STAFF REPORT: 04/09/2025

APPLICATION NUMBER: HDC2025-00060

ADDRESS: 14520 ASHTON

SCOPE: REPLACE VINYL WINDOWS WITH VINYL WINDOWS

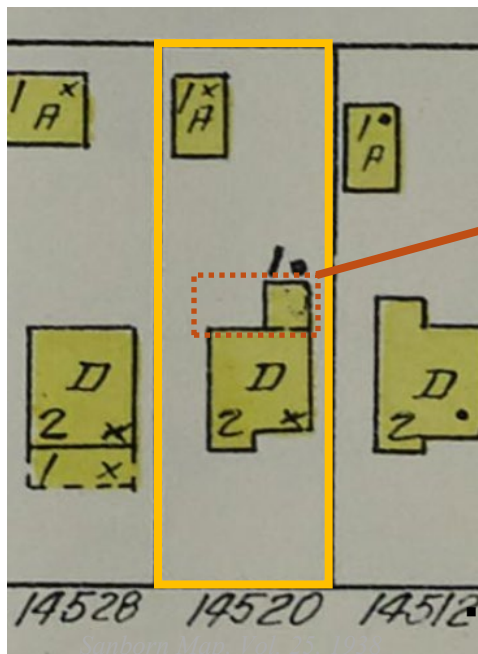
- Replace four white vinyl windows with white vinyl windows
 - (1) Back of house, first floor, North elevation
 - (2) Back of house, first floor, East elevation
 - (1) Back of house, first floor, South elevation

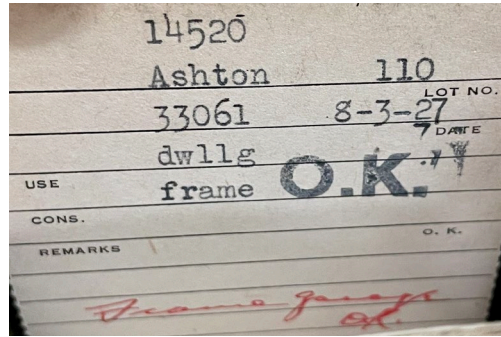
- Rear portion was expanded sometime between 1938 and 2009, though no records were found in BSEED.
